ADDENDUM NO. 01

RANKIN TRAILS AMPHITHEATER AND BASEBALL PARK

Rankin County, Mississippi

WBA Proj. # 2215/2315

7 SECTION @ FRONT OF STAGE
S4.3 SCALE: 3/4"=1'-0"

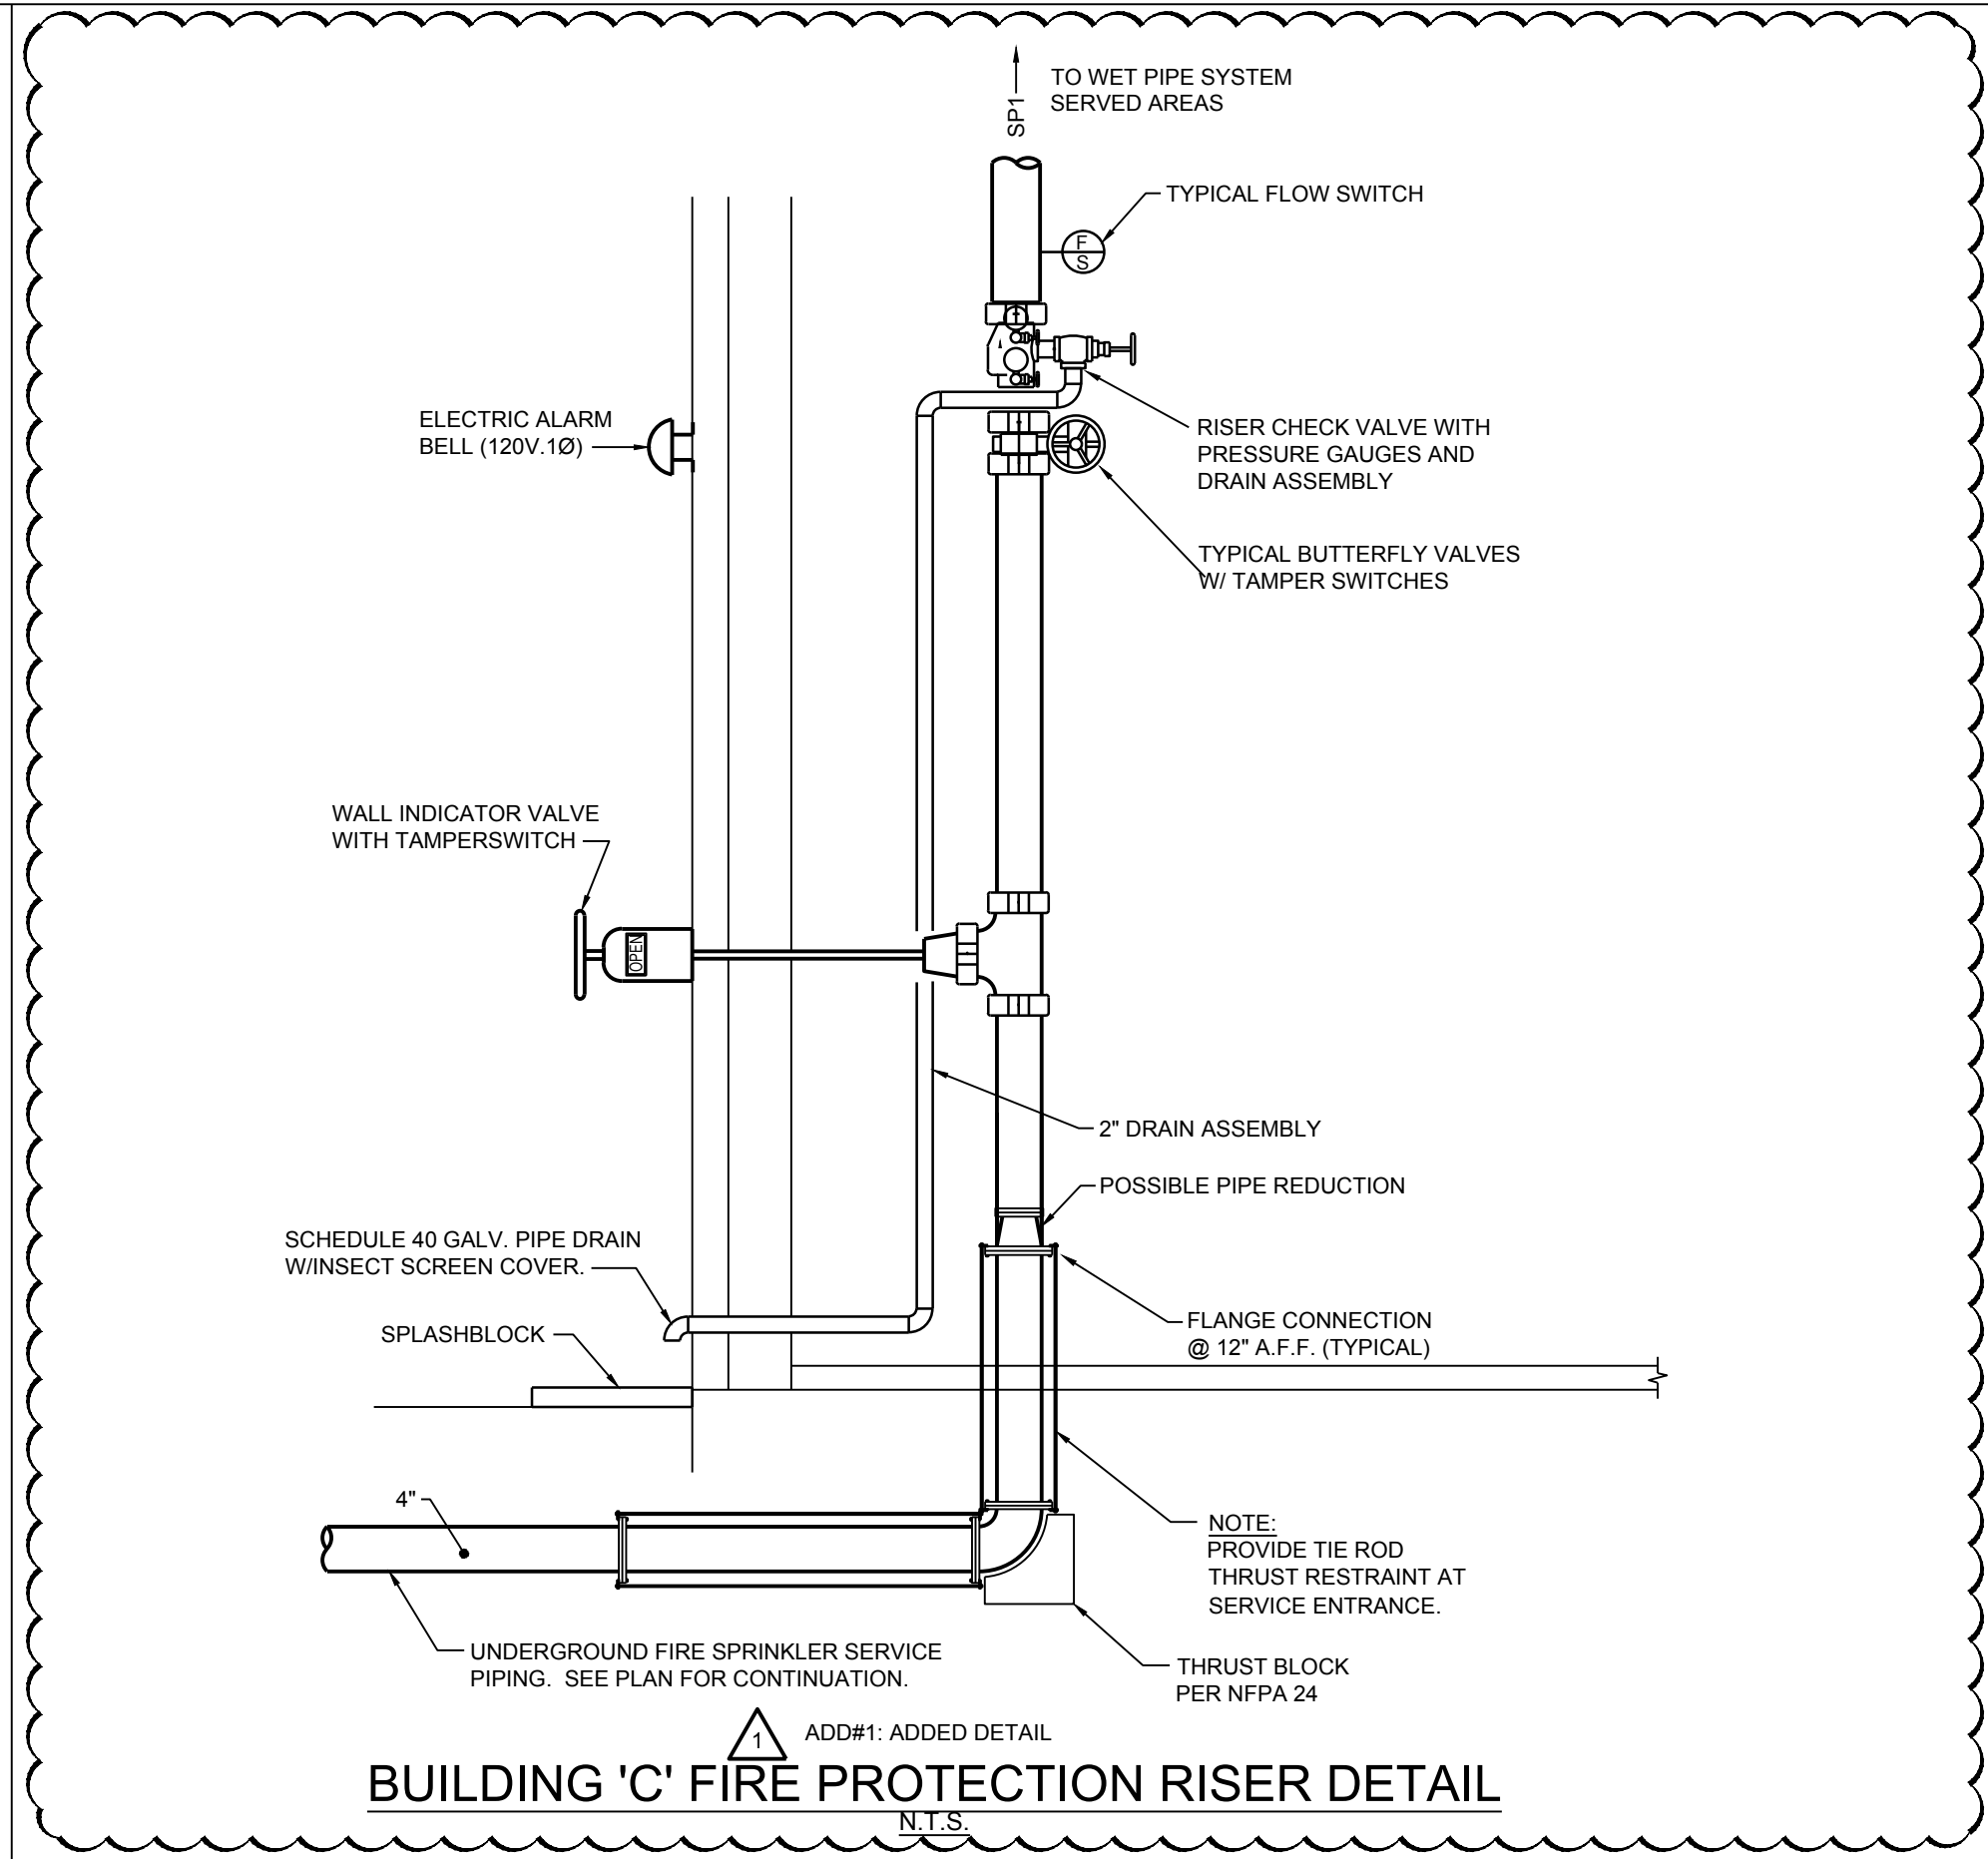
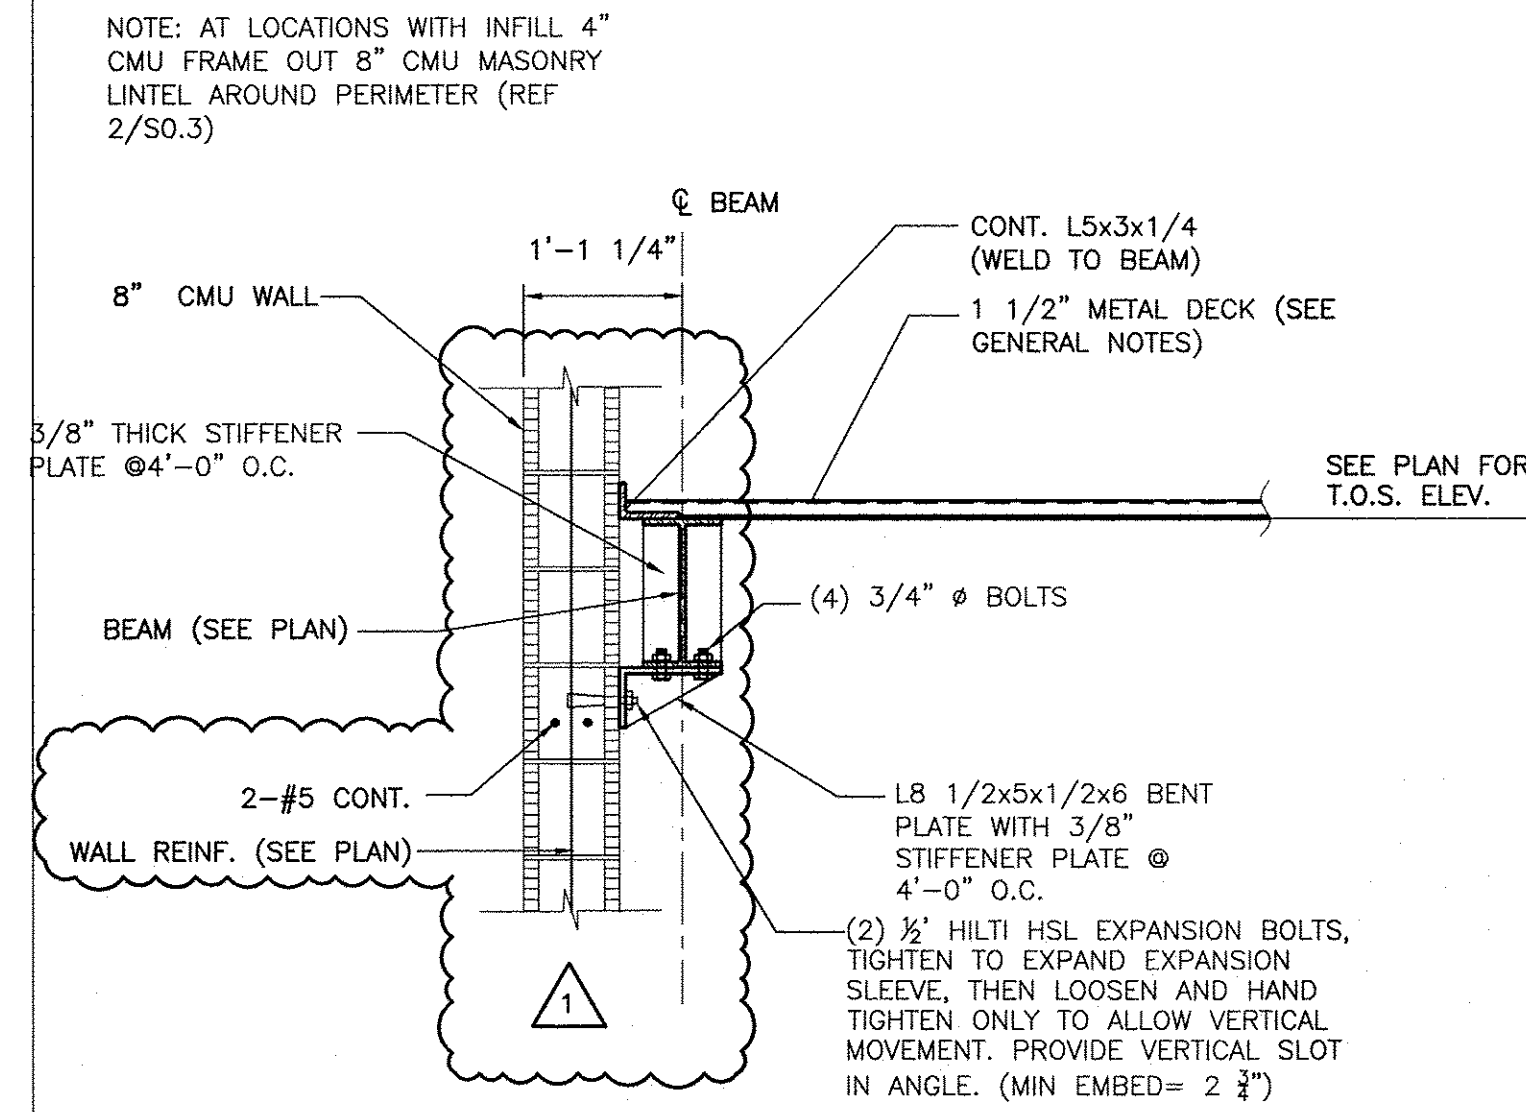
- ITEM NO. 15** **SHEET S3.1 ELEVATIONS**
ADD missing text, per enclosed revised sheet S3.1.
- ITEM NO. 16** **SHEET S4.3 SECTIONS**
REVISE wall reinforcement extents, per enclosed revised sheet S4.3.
REVISE wall reinforcement, per enclosed revised sheet S4.3.
REVISE embedded bolt size and depth, per enclosed revised sheet S4.3.
ADD roof deck detail, per enclosed revised sheet S4.3.
